Access Compliance Report

Public Rights-of-Way

Intersection ID: 48945	Main Street: DAVID_JENNINGS_AV	Cross Street: CALDWELL_RIDGE_PY	Location: SW
ADA ID: C1CF09DFCE83	Ramp Type: Perp	Initial Pass/Fail: Fail	Overall Compliance: No
Severity Score: 8.75			
Codes/Mitigation Info/Possible Solution		Field Measurements/Component Compliance

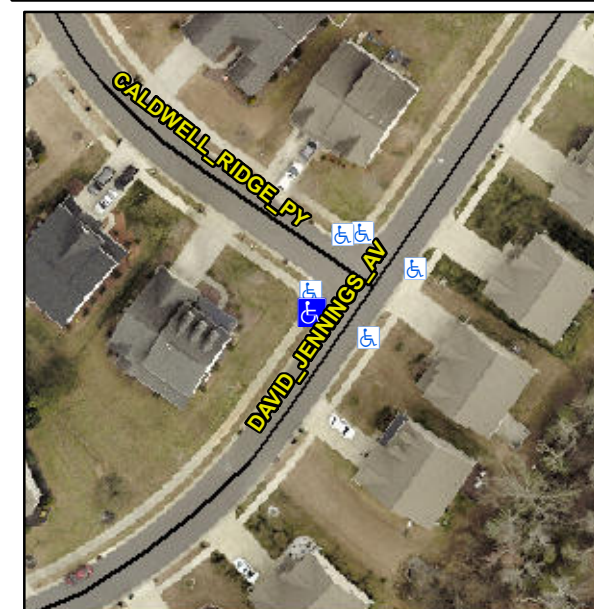
Not Found, R304.5.1

Compliance	Description	Data	Compliance	Description	Data
N/A	Ramp Length (in)	47.5	Yes	Ramp Slope (%)	7.5
No	Ramp Width (in)	43.5	Yes	Ramp XSlope (%)	1.9
N/A	Flare Type LT	N/A	N/A	Flare Type RT	N/A
N/A	Flare Slope LT (%)	N/A	N/A	Flare Slope RT (%)	N/A
N/A	Flare Traversable LT?	N/A	N/A	Flare Traversable RT?	N/A
N/A	Landing Length (in)	N/A	N/A	DWS Provided?	N/A
N/A	Landing Width (in)	N/A	N/A	DWS Contrast?	N/A
N/A	Landing Slope (%)	N/A	N/A	DWS Length (in)	N/A
N/A	Landing X Slope (%)	N/A	N/A	DWS Full Width?	N/A
N/A	Landing Curb? (Y/N)	N/A	N/A	DWS Offset (in)	N/A
N/A	Shared Landing?	N/A			
N/A	Gutter Ponding?	N/A	N/A	Gutter Slope (%)	N/A
N/A	Gutter Lip Ht (in)	0.5	N/A	Gutter X Slope (%)	N/A
N/A	Painted X Walk1?	No	N/A	Painted X Walk2?	N/A
	X Walk 1 Direction	To SE		X Walk 2 Direction	N/A
N/A	X Walk 1 Width (in)	N/A	N/A	X Walk 2 Width (in)	N/A
	X Walk 1 Slope (%)	0.7		X Walk 2 Slope (%)	N/A
	X Walk 1 X Slope (%)	2.0		X Walk 2 X Slope (%)	N/A

Remove & Replace Entire Ramp.
